ZONING BOARD OF APPEALS STAFF REPORT

REGARDING: HOMEWOOD SUITES (CASE NO. PZ15-0001)

PLAN REVIEW CENTER REPORT

Revised Preliminary Site Plan

DATE
DRAWN : ACA
CHECKED : JP
SCALE : 1"=30'
JOB NO : BD-14-235
SHEET TITLE
SITE LAYOUT AND PAVING PLAN
SHEET

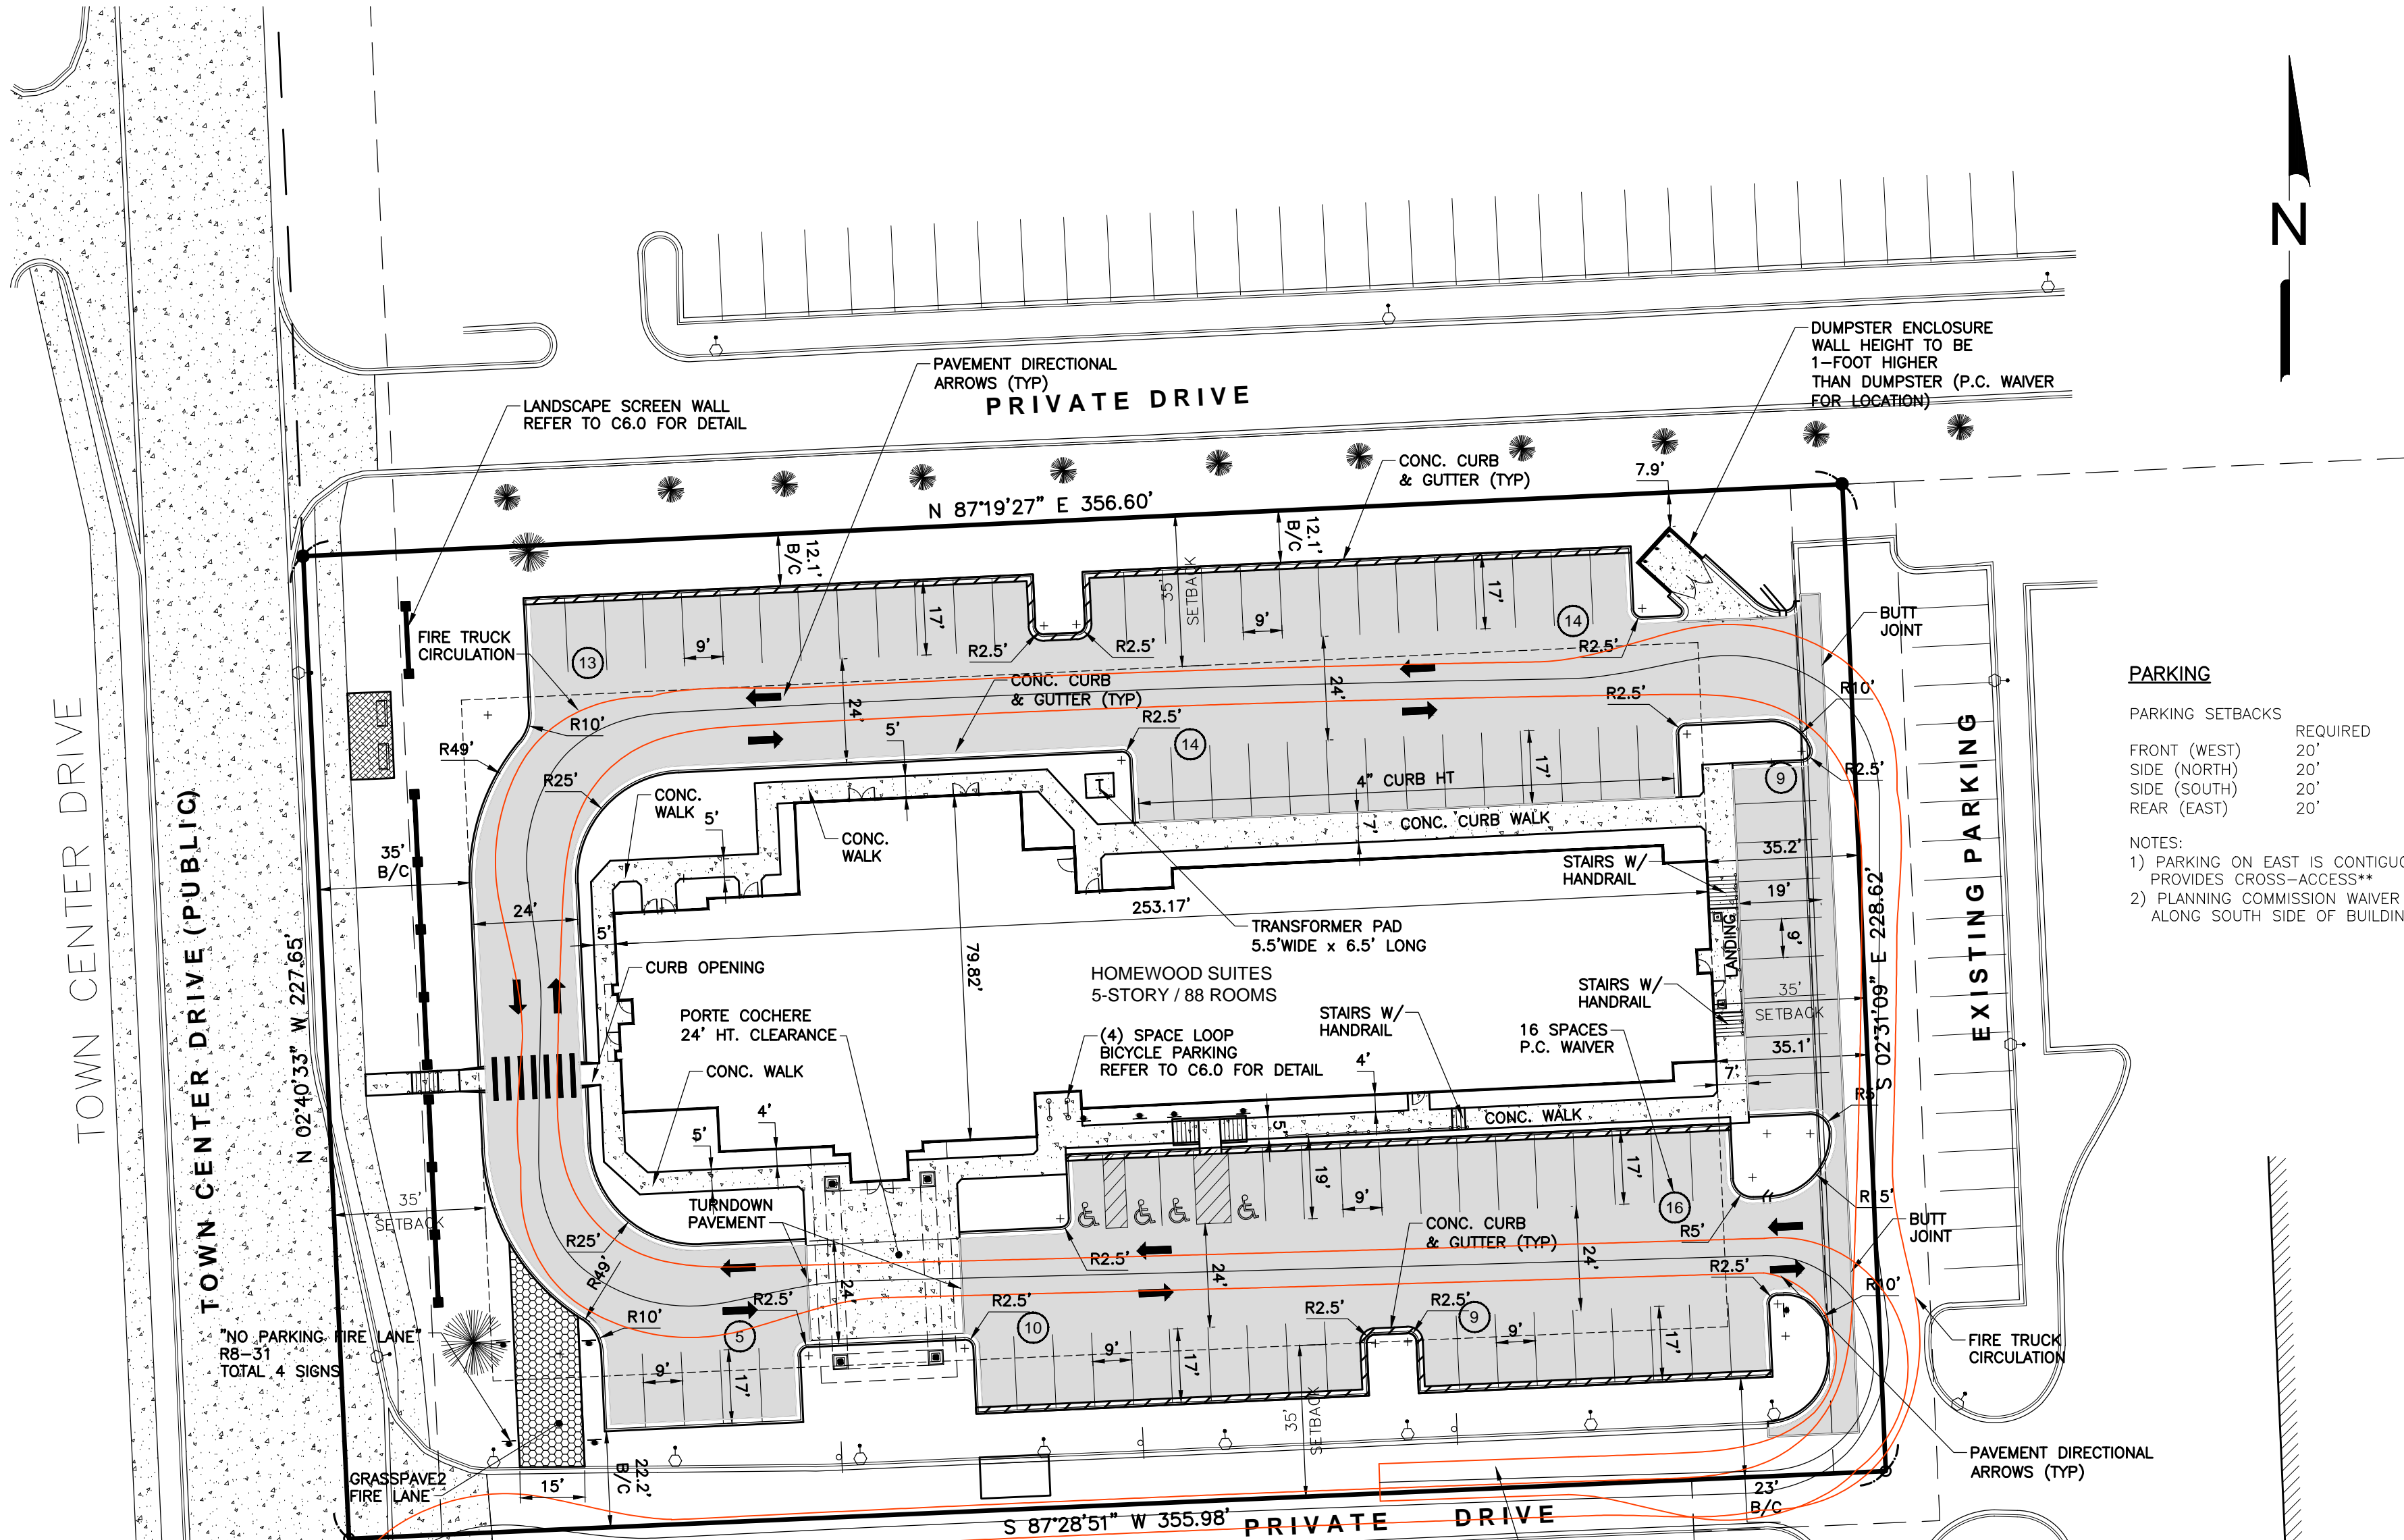
- a. Directional arrow pavement markings have been added to sheet C3.0 and detailed on sheet C6.0.
- b. The applicant has indicated where the handicap parking signs shall be located within the site; however, the van accessible parking signing is not compliant, as follows:
 - i. The applicant should consider installing an R7-8 sign as well as an R6-7P sign in front of the van accessible space, instead of just the R7-8P sign as indicated on the plan.
 - ii. The applicant should update the Traffic Control Sign Table on sheet C3.0 to include four (4) R7-8 signs.

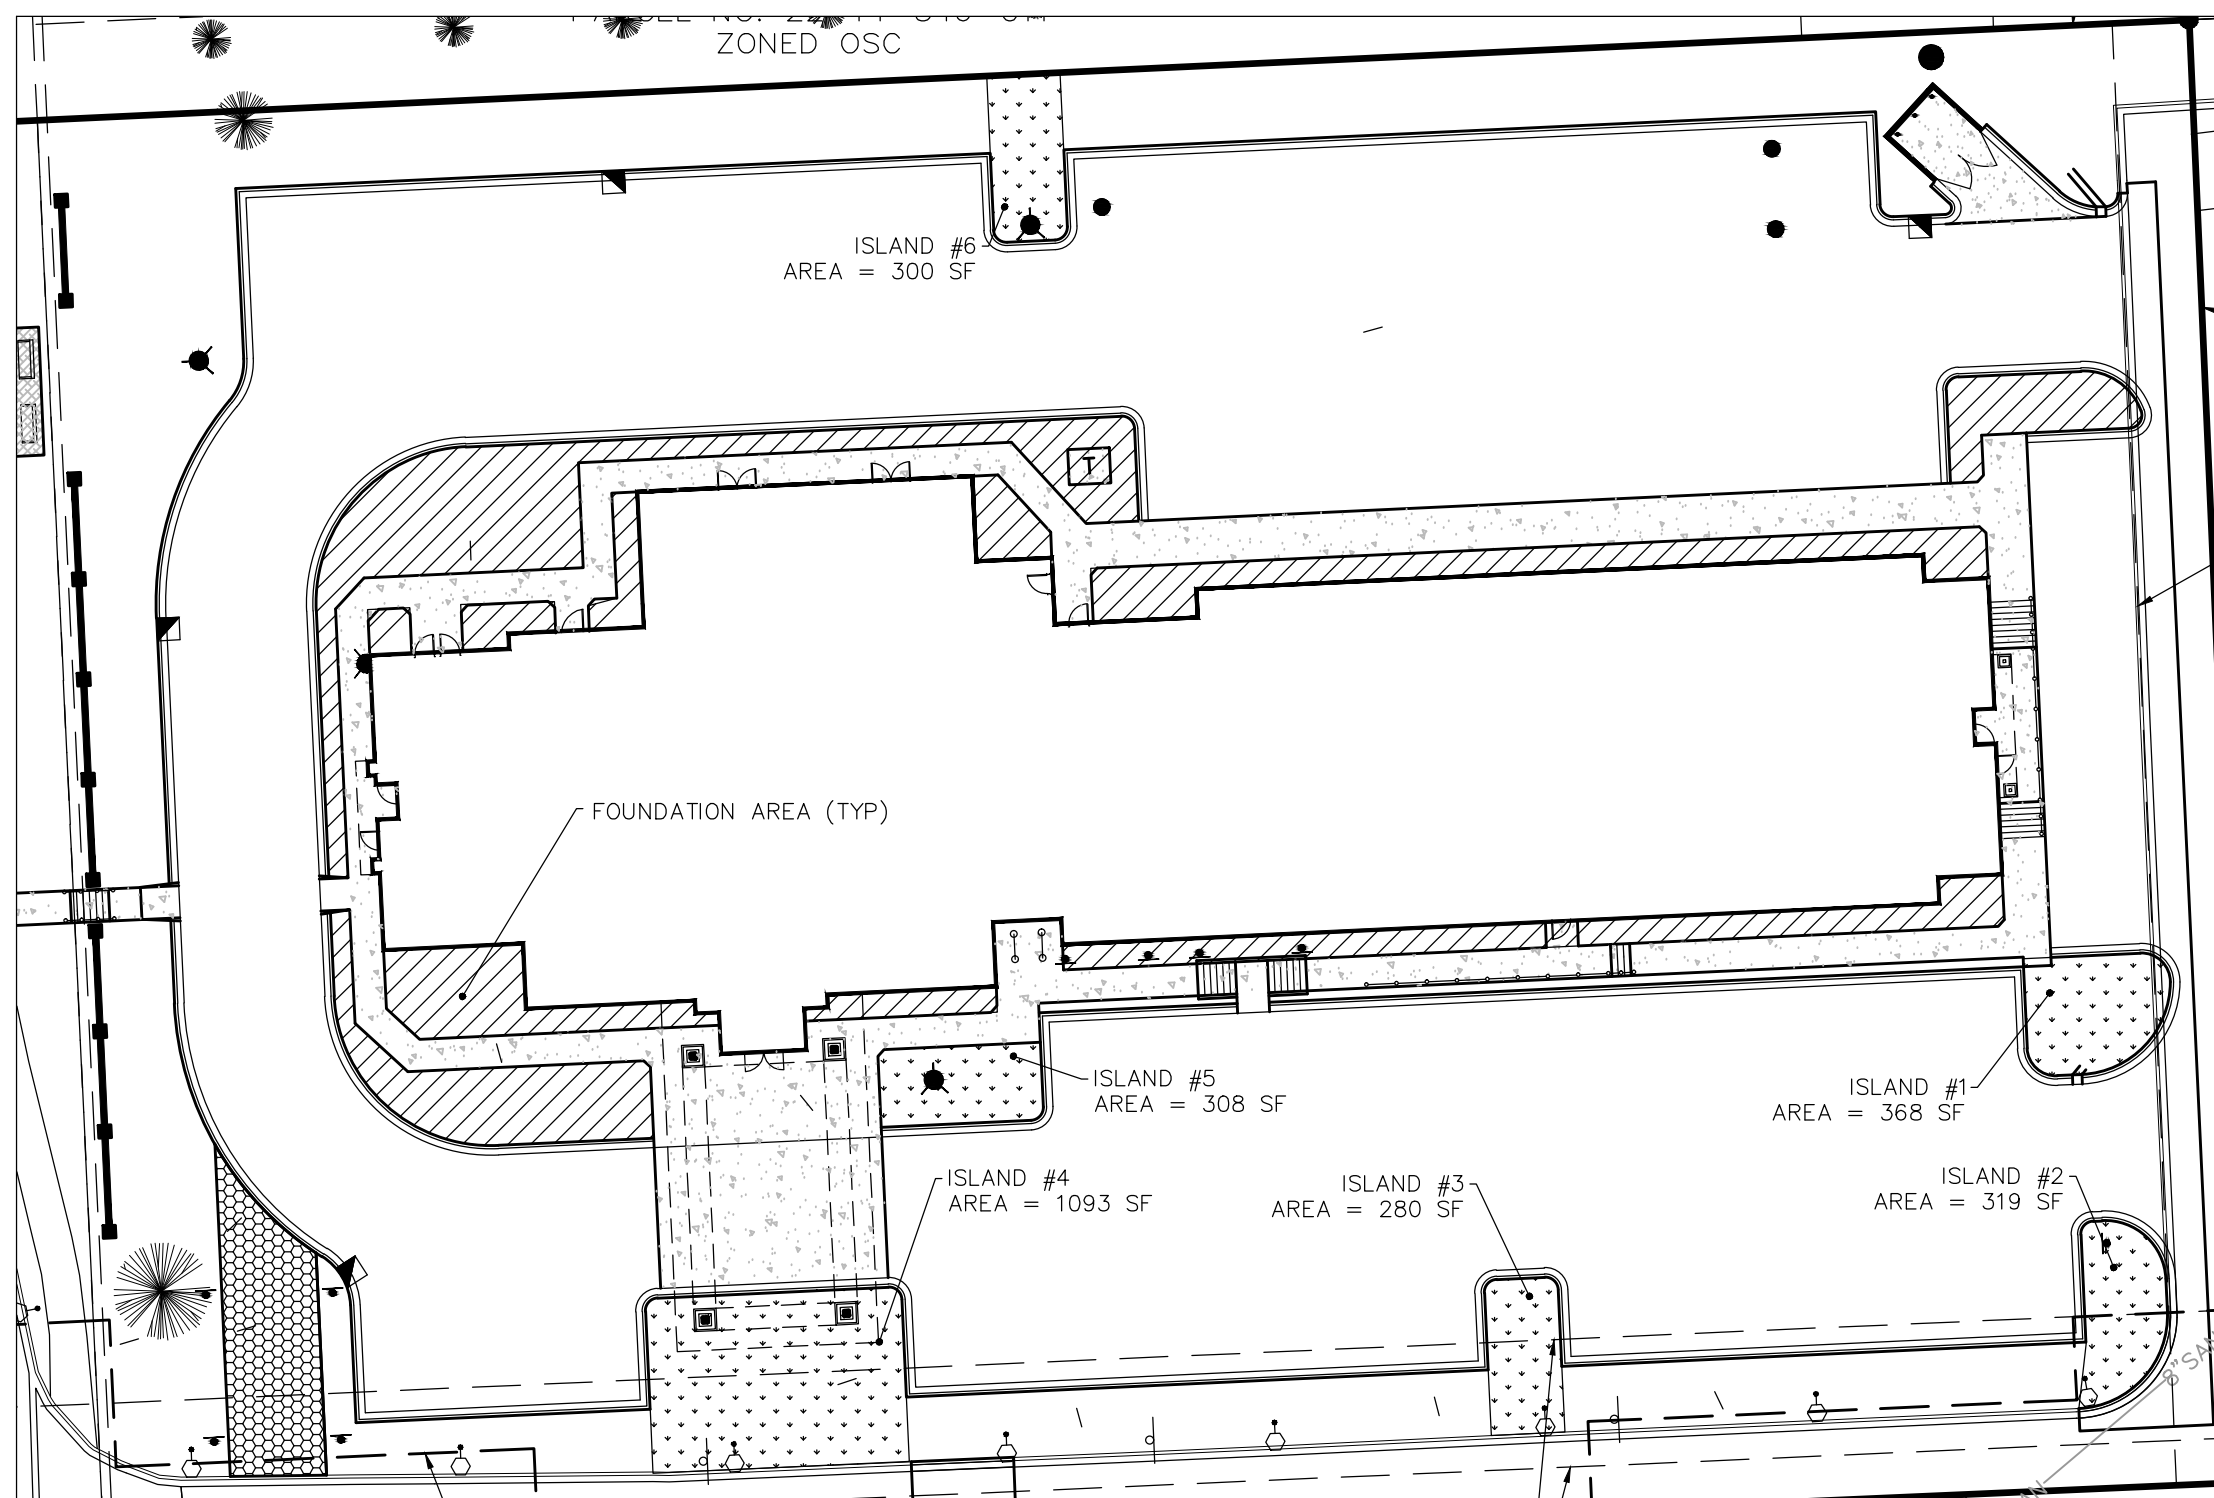
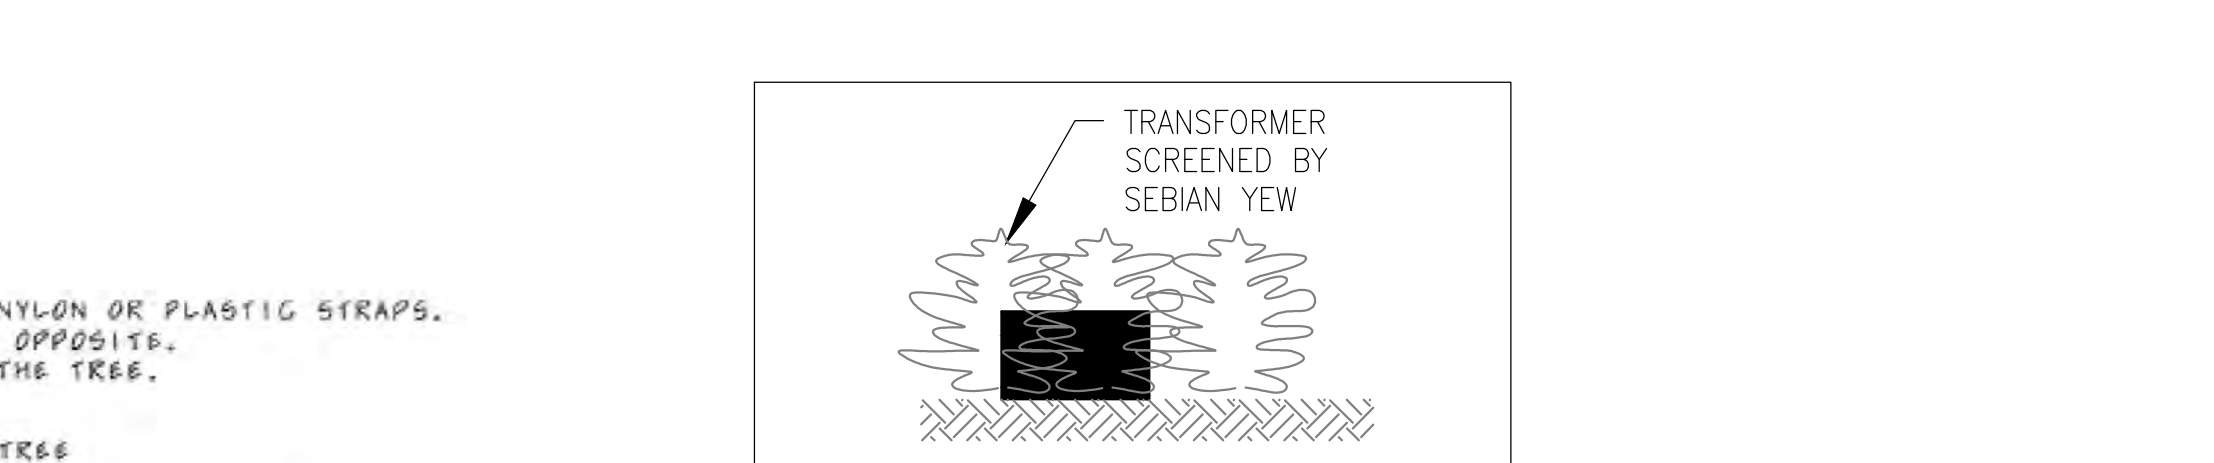
- 7) **Added item 4/9 - landscape page #L1.0 shows approx.6 bushes blocking new fire hydrant new main entrance. Per IFC 2006, 3' of clearance must be maintained in all directions around fire hydrants.**
